This document contains the latest information about the AVR data book and the AVR data sheets.

All references to the data book refers to the August 1999 version of the "AVR[®] RISC MICROCONTROLLER DATA BOOK".

**8-Bit AVR[®]
Microcontroller**

**AVR[®] Data
Book Updates
and Changes**

Figure 34 Serial Programming and Verify

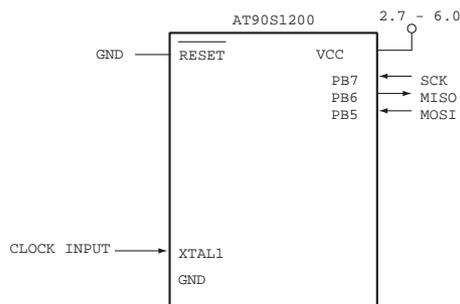
2-44 Replace figure 34 by the one below:

Figure 53 Serial Programming and Verify

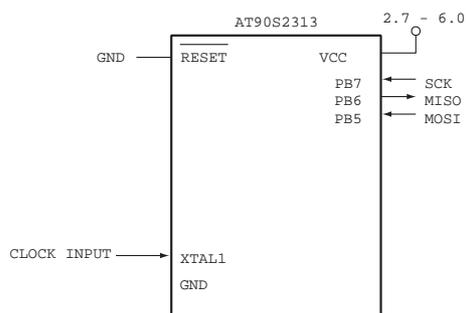
- 3-54 in the **Port D Input Pins Address - PIND** description, change the Initial Values of bits 0 to 6 from “Hi-Z” to “N/A”.
- 3-67 Replace figure 34 by the one below:

Figure 66. Serial Programming and Verify

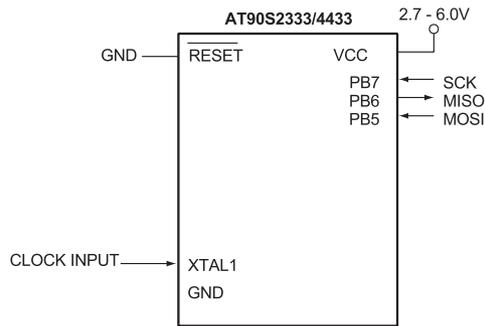
- 5-68 In the **Port D Input Pins Address - PIND** description, change the Initial Values from "Hi-Z" to "N/A".
- 5-80 In **"Serial Downloading"**, replace Figure 66 by the figure below.

Figure 64 Serial Programming and Verify

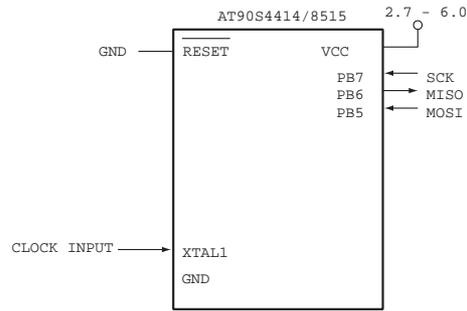
- 6-66 in the **Port D Input Pins Address - PIND** description, change the Initial Values from “Hi-Z” to “N/A”.
- 6-79 Replace **figure 64** by the one below:

Figure 40. SPI Transfer Format with CPHA = 1 and DORD = 0

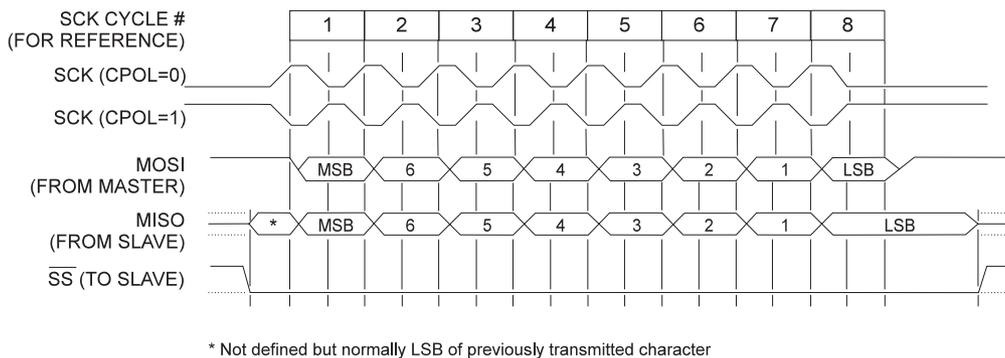
7-52 Change **Figure 40** to the figure below.

Figure 71. Serial Programming and Verify

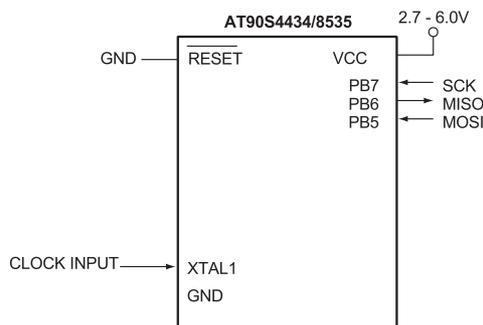
7-91 In “**Serial Downloading**”, replace Figure 71 by the figure below.

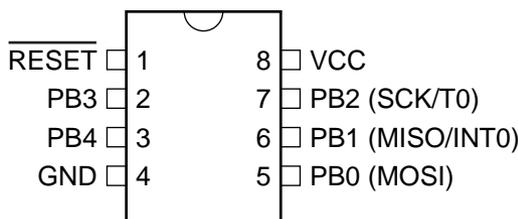
11-3 Replace **Pin Configuration** by the figure shown below.

Figure 1. The ATmega603/103 Block Diagram

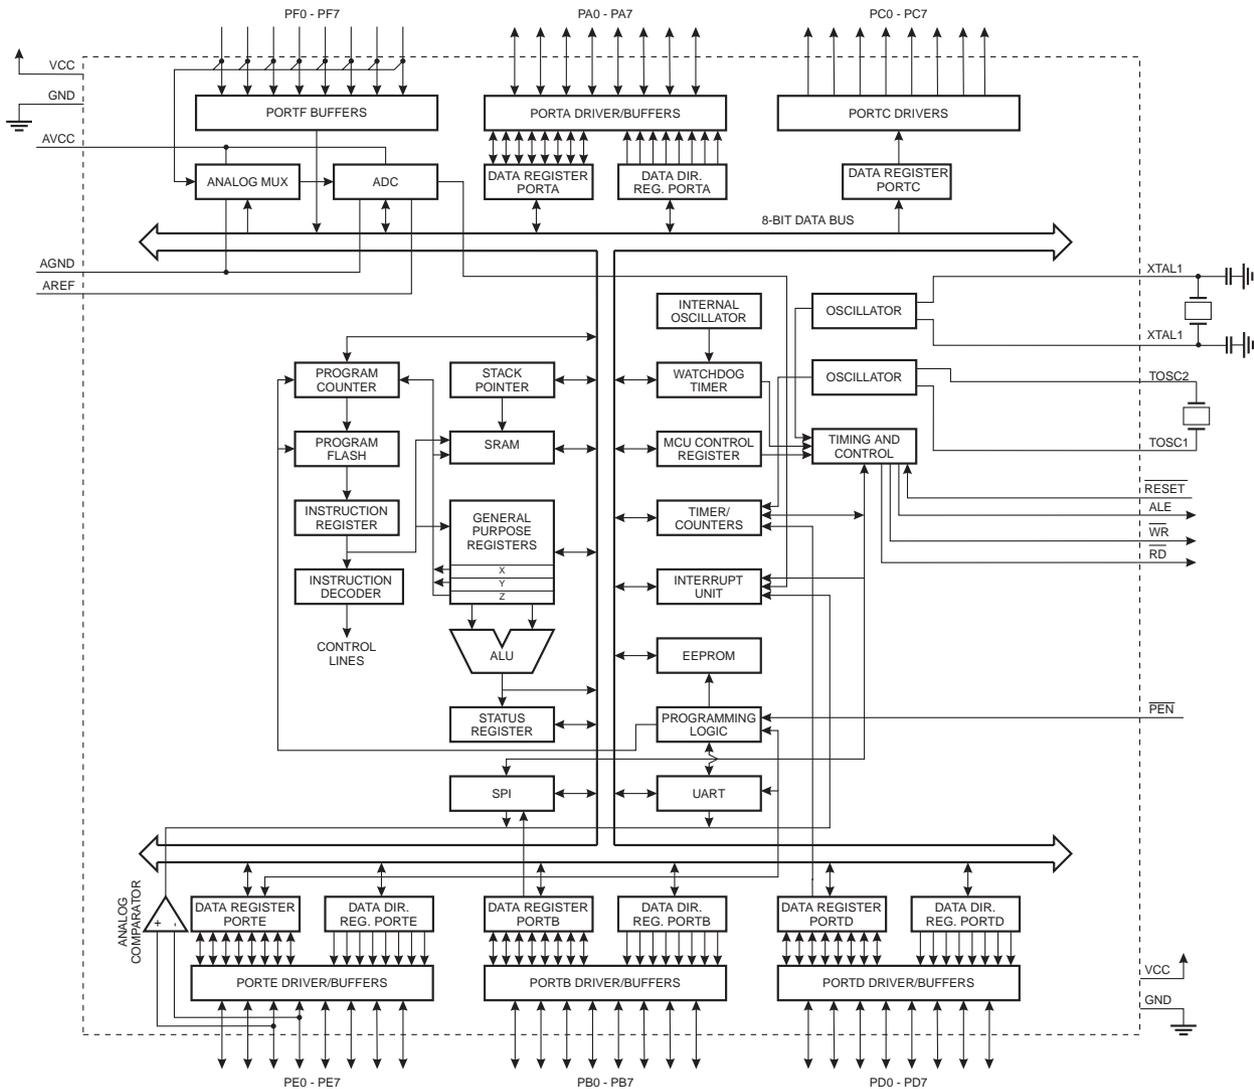
13-5 Some text and symbols are outside the visible figure frame. The complete figure is given below.

Figure 39. SPI Transfer Format with CPHA = 0 and DORD = 0

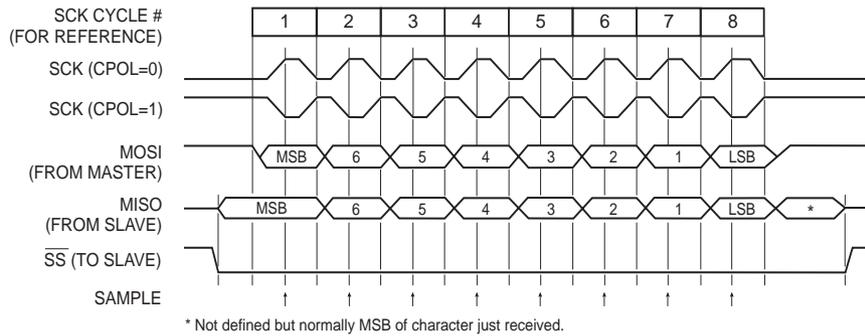
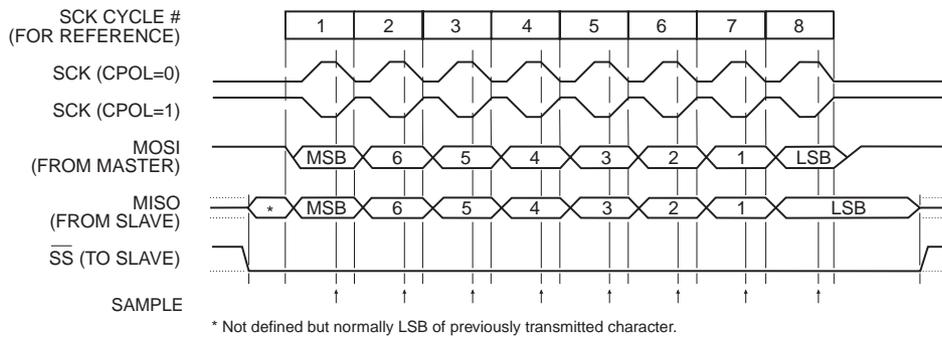
- 13-59 Replace figure 39 and 40 by
